T ECHNICAL INFORMATION

A0836

Subject ▶ Change of Switch, Terminal and Housing set

For Models ▶ BDF343, BHP343

▶ Circuit diagram

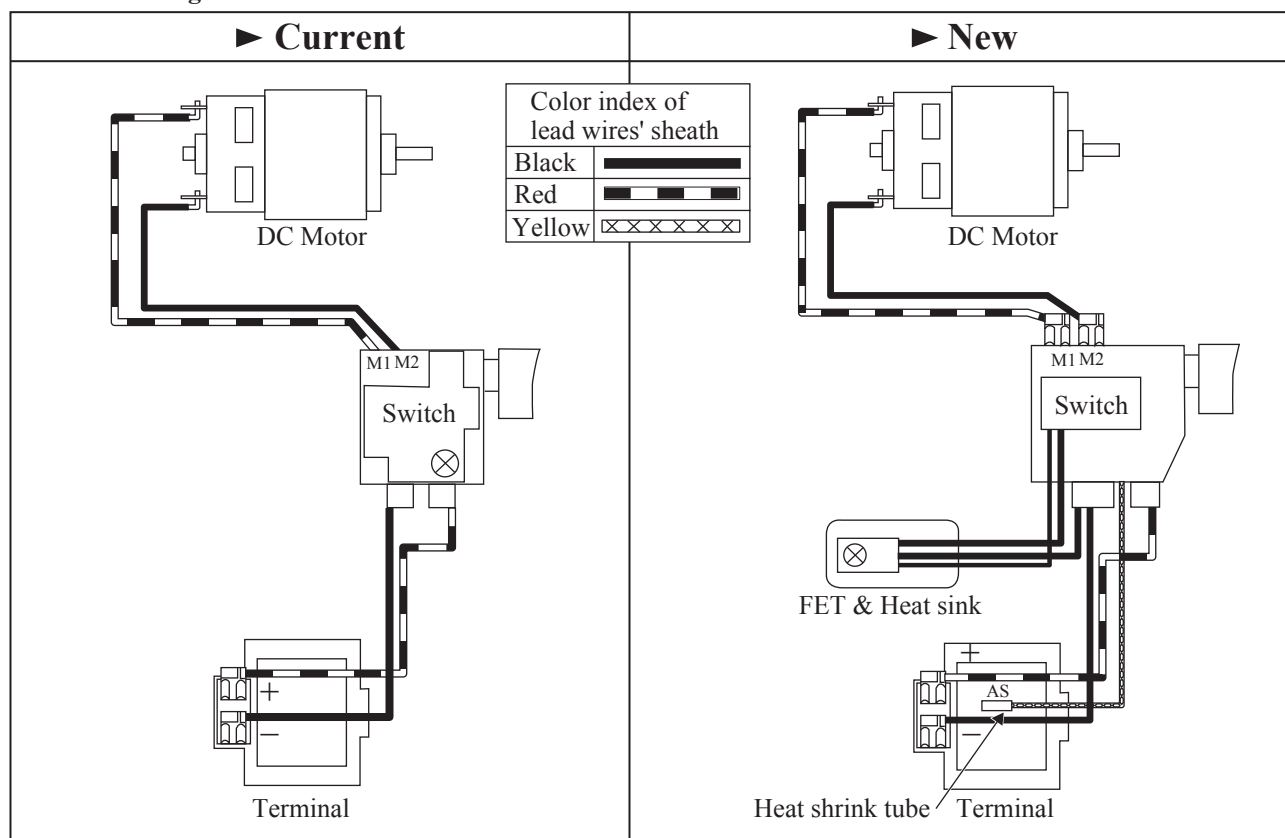
Description ▶ Switch, Terminal and Housing set has been changed to feature battery protection. Therefore, the wiring has been changed as illustrated below.

Note: • Use new parts for repair of the model with Yellow lead wire between Controller and Terminal.

• Use current parts for repair of the model without Yellow lead wire between Switch and Terminal.

► Wiring diagram

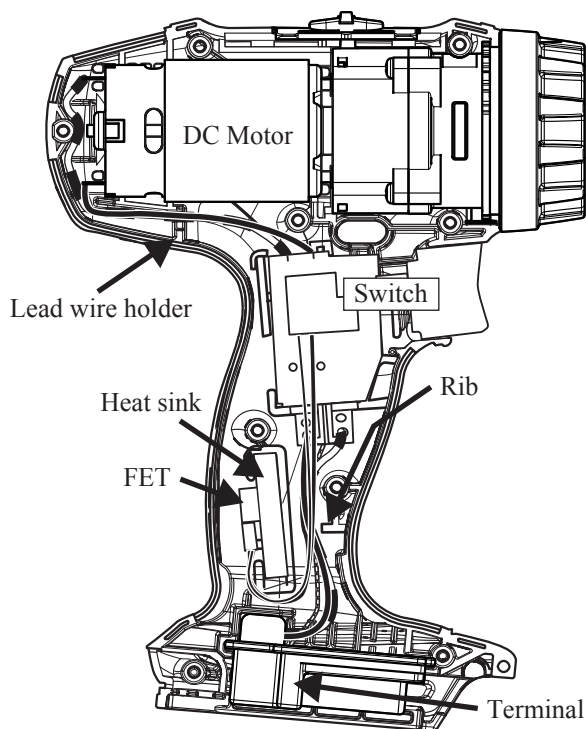
Reference No. (See page 1.)	► Current	► New
②	<p>6438289 > PBT <</p> <p>14.4v</p> <p>Minus terminal Plus terminal</p>	<p>6438548 > PBT <</p> <p>14.4v</p> <p>AS terminal Minus terminal Plus terminal</p>
③ ④	<p>Housing (L)</p> <p>Housing (R)</p>	<p>Housing (L)</p> <p>Housing (R)</p> <p>Rib shapes have been changed due to change of Switch.</p>
